Access Compliance Report

Public Rights-of-Way

(Curb Ramps)

Intersection ID: 5180	Main Street: HUBBARD_RD	Cross Street: MORSEY_CT	Location:	E
ADA ID: A86921B5AD9B	Ramp Type: Perp	Initial Pass/Fail: Fail	Overall Compliance: No	Severity Score: 12.5
Codes/Mitigation Info/Possible Solution		Field Measurements/Component Compliance

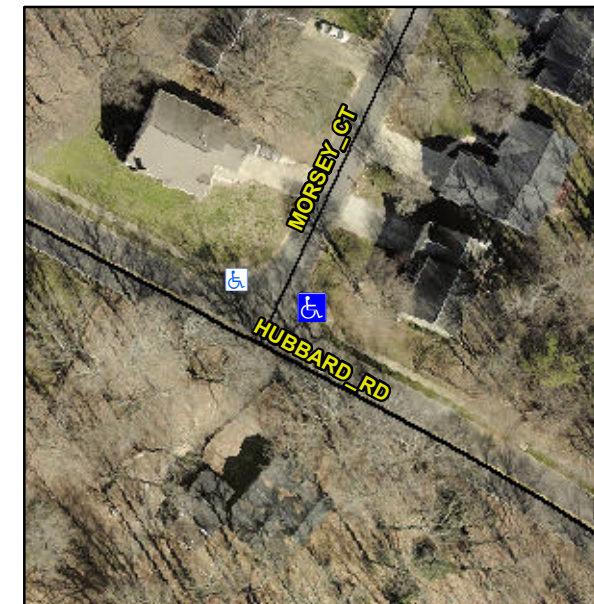
R304.2.2

Compliance	Description	Data	Compliance	Description	Data
N/A	Ramp Length (in)	48.0	No	Ramp Slope (%)	10.3
Yes	Ramp Width (in)	55.0	Yes	Ramp XSlope (%)	2.0
N/A	Flare Type LT	N/A	N/A	Flare Type RT	N/A
N/A	Flare Slope LT (%)	N/A	N/A	Flare Slope RT (%)	N/A
N/A	Flare Traversable LT?	N/A	N/A	Flare Traversable RT?	N/A
N/A	Landing Length (in)	N/A	N/A	DWS Provided?	N/A
N/A	Landing Width (in)	N/A	N/A	DWS Contrast?	N/A
N/A	Landing Slope (%)	N/A	N/A	DWS Length (in)	N/A
N/A	Landing X Slope (%)	N/A	N/A	DWS Full Width?	N/A
N/A	Landing Curb? (Y/N)	N/A	N/A	DWS Offset (in)	N/A
N/A	Shared Landing?	N/A			
N/A	Gutter Ponding?	N/A	N/A	Gutter Slope (%)	N/A
N/A	Gutter Lip Ht (in)	N/A	N/A	Gutter X Slope (%)	N/A
N/A	Painted X Walk1?	No	N/A	Painted X Walk2?	N/A
	X Walk 1 Direction	To NW		X Walk 2 Direction	N/A
N/A	X Walk 1 Width (in)	N/A	N/A	X Walk 2 Width (in)	N/A
	X Walk 1 Slope (%)	4.7		X Walk 2 Slope (%)	N/A
	X Walk 1 X Slope (%)	1.6		X Walk 2 X Slope (%)	N/A

Remove & Replace Entire Ramp.
